MCPB

Item No.: 4B.

Cashell Estates, Conditional Use No. CU 2016-11

Cashell Estates CU 2016-11

Figure 6 – Conditional Use Plan

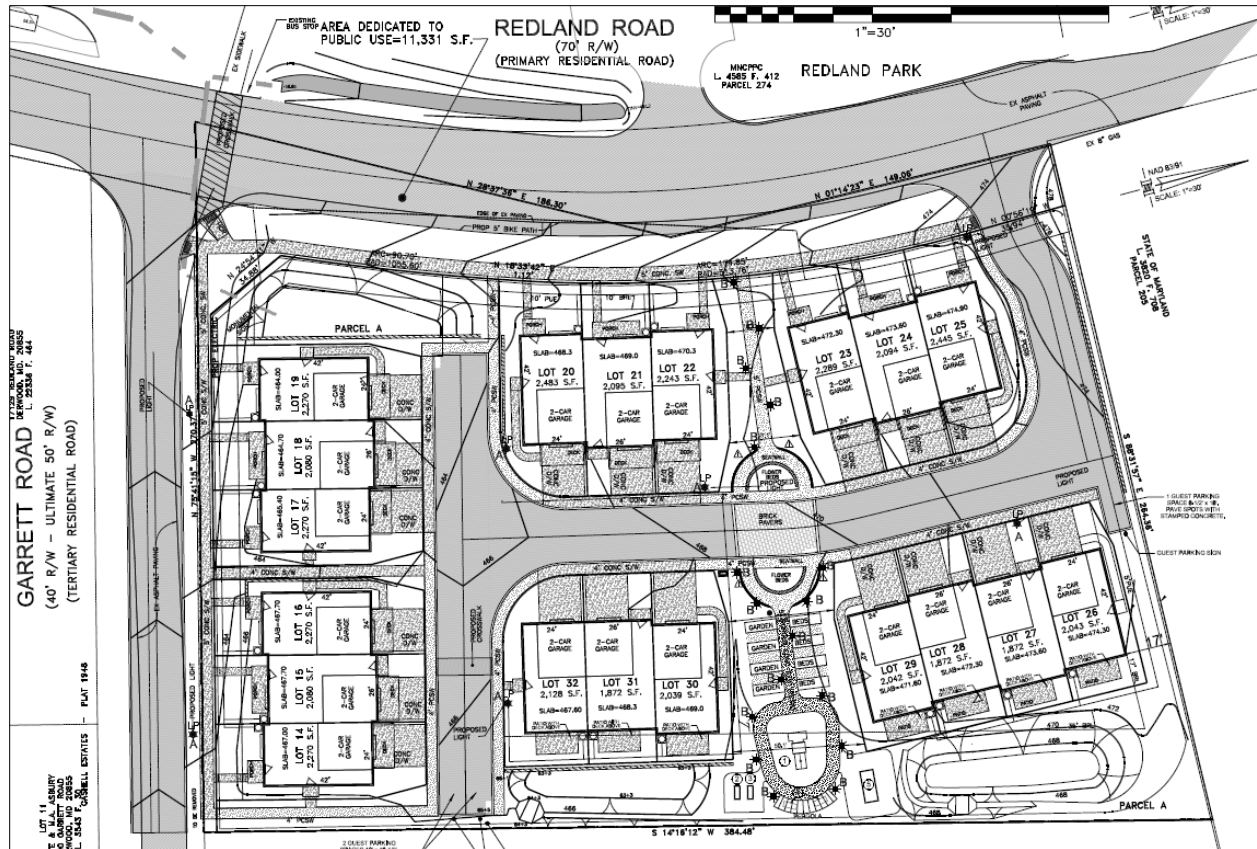
* The proposed common open space does not entirely meet the 50-foot minimum width requirement of Section 6.3.5.B.2 and requires an exception be granted by the deciding body. The width ranges from 18 feet at the west to 50 feet at the west (widest point). Although the space does not meet the width requirement, Staff believes that an exception is warranted because the open space meets the intent of Division 6.3. As described on page 13 of this report, the proposed common space meets the intent because it is centrally located within the development, provides a break between the individual rows of townhouses, provides passive and active recreation including seating, a pergola, accessible garden beds and specialty play equipment designed for those with disabilities. The space is well connected with sidewalks and will be a welcoming space for visitors and residents.

- 5) No fence constructed on the lots with frontage on Redland Road and Garrett Road may exceed four feet in height.
- 6) The common open space area must include a pergola, six raised planted beds, and 3 log benches as shown on the conditional use plan.

Figure 12 - Landscaping and Lighting Plan

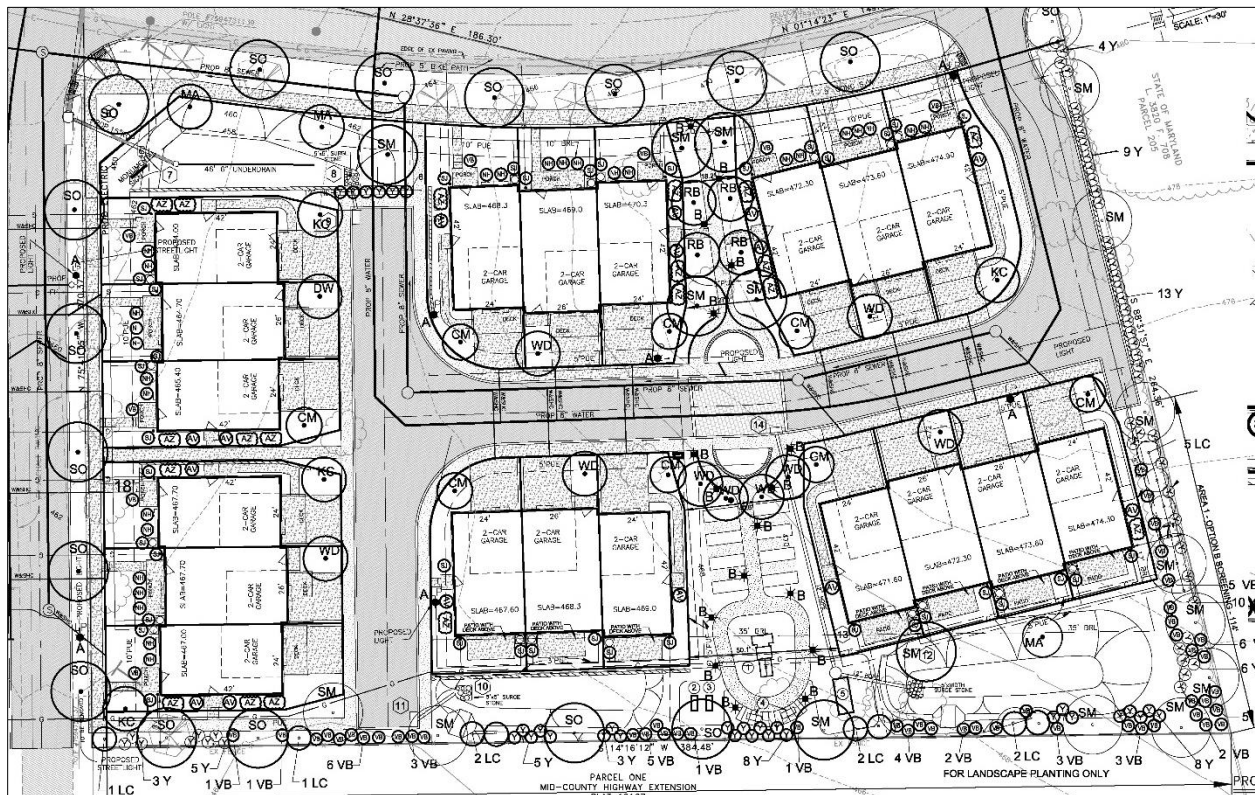
The width of the screening area along the northern Property line is narrower than either of the standard panels in Section 6.5.3.C.4 due to the unique nature of the Conditional Use and the restrictive grading required to meet ADA and vehicle access. The screening area is three feet wide and approximately two to three feet below the grade of the adjoining MDSA property.

The Property is required to be graded to five percent or less and provide at least one no-lip entrance to each townhouse in order to meet the townhouse living conditional use requirements. In order to meet those requirements, the Applicant will install a 30-inch high precast concrete retaining wall which will take up some of the existing grade along the northern Property line. This leaves a three-foot-wide planting space to install the landscape screening materials required under Section 6.5.3. The Applicant proposes to install a continuous row of short evergreen shrubs and three canopy trees within this area. Staff has

determined that due to the unique site characteristics and development constraints that the screening requirements under Section 6.5.3 cannot be met and that the alternative design satisfies the intent of Section 6.5. which is to ensure appropriate screening between different building types and uses.

Figure 13 –Lighting/Photometric Plan

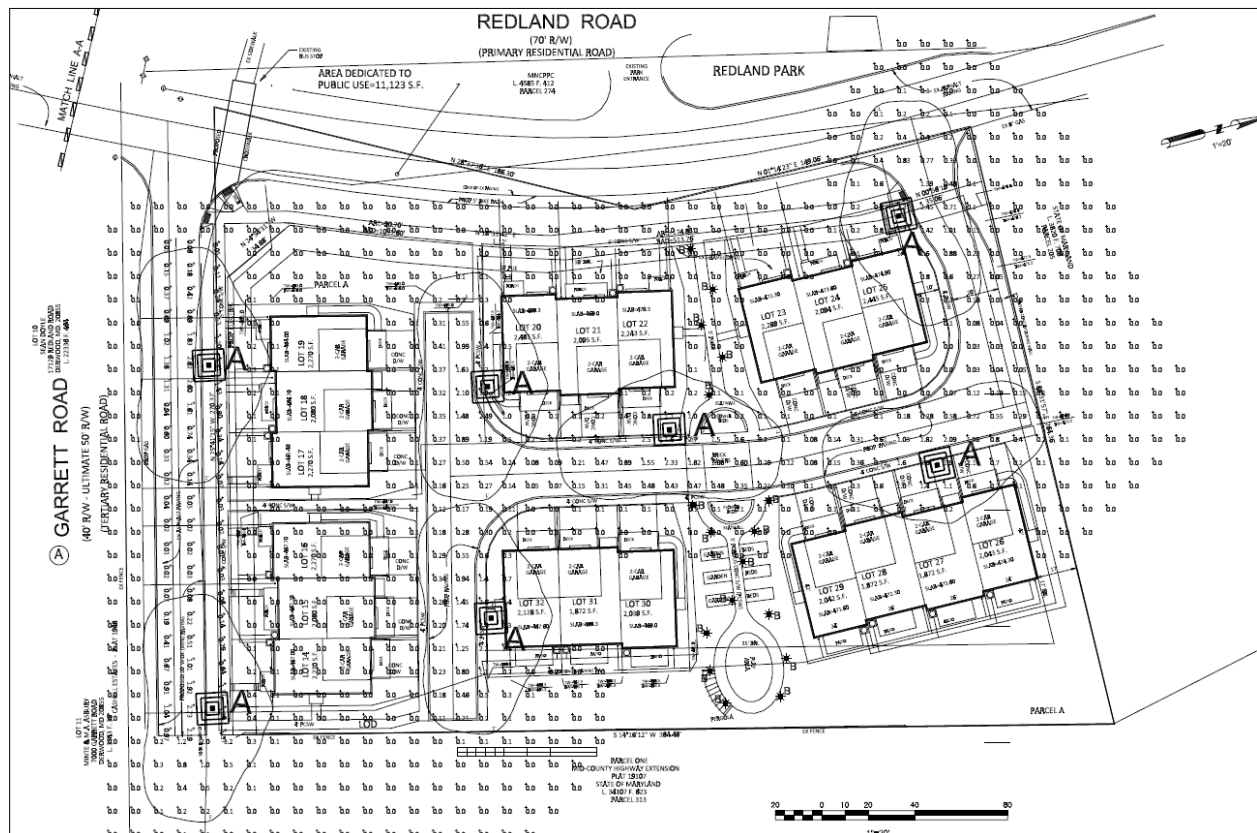
The Applicant proposes seven pole mounted lighting fixtures to illuminate the Subject Property which will be Residential Colonial post-top, LED optics with Type III light distribution. The Applicant also proposes 17 bollard style lights specifically for pedestrian illumination along the walking path in the mews area. Each of the 17 pole mounted light fixtures will be installed at a height of 12-feet above ground and each of the 17 bollards will be 30-inches in height.

All of the pole mounted lights are LED fixtures with full cut-off to eliminate horizontal light cast. The photometric plan predicts that no light above 0.01 foot-candles will spill across any Property boundary which satisfies the requirements of Section 6.4.4.E. The lighting will be adequate, providing visibility to the areas for vehicular and pedestrian circulation during nighttime hours. The lighting will not have a negative impact to neighboring property owners with either direct light or light glare. The bollard lights are LED fixtures fitted with angled louvers to reduce horizontal light spread and concentrate the light in the immediate area around the bollard. The lighting output of the bollards do not appreciably increase the total lumens of the overall lighting plan and as a result their calculations were not include in the photometric plan.

Figure 14 – Proposed Monument Sign (Name undetermined)

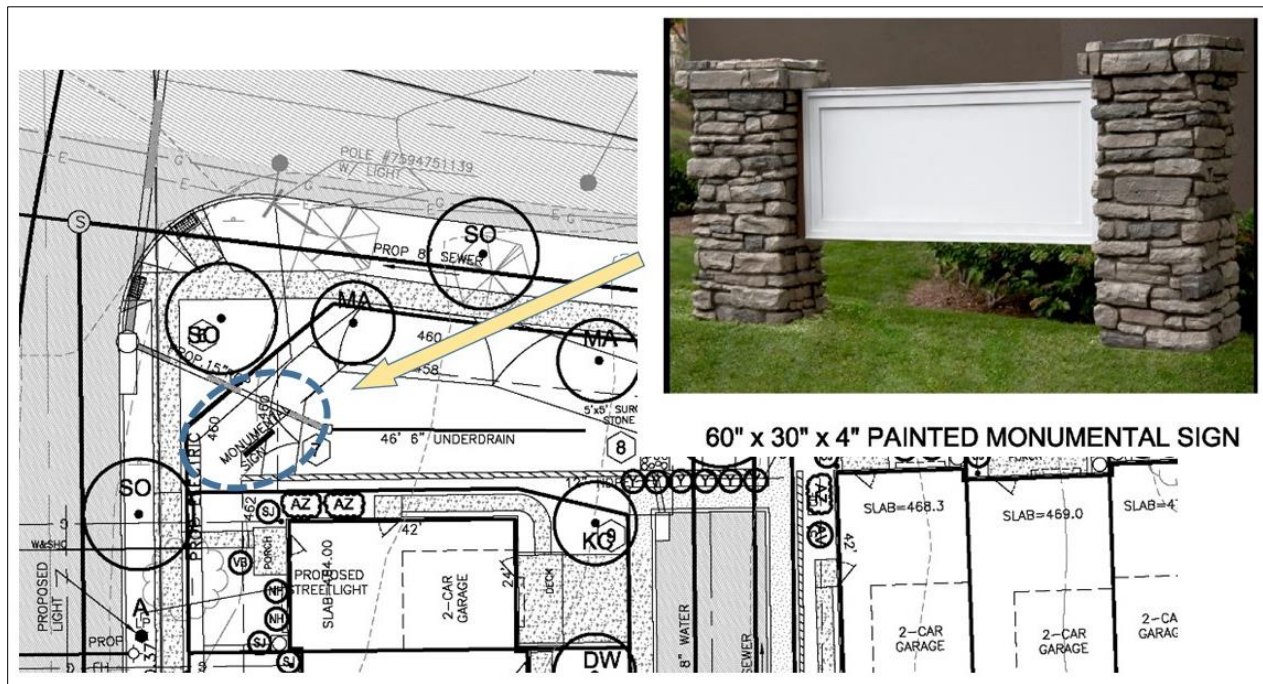
The Application proposes a painted monument style sign (5'w x 2 ½'h) at the southwest corner of the Property which will be anchored between two five-foot-tall faux stone pillars. The ground level monument sign will be at a scale and location that is consistent with the existing signage for similar residential subdivisions in the Neighborhood. The sign will be low to the ground, and constructed of masonry/stone veneer and wood. The sign will also be setback on the Property so as not to obstruct

drivers views the intersection of Garrett Road and Redland Road. The dimensions of the proposed signage area acceptable under Section 6.7.8. There are similar monumental signs in the Neighborhood. One to the north of the Subject Property, on the west side of Redland Road at its intersection with Roselyn Ave. The second is on the east side of Redland Road at its intersection with Roslyn Ave, which is constructed of wood. The proposed sign will be compatible with the existing character of the residential properties in the Neighborhood.
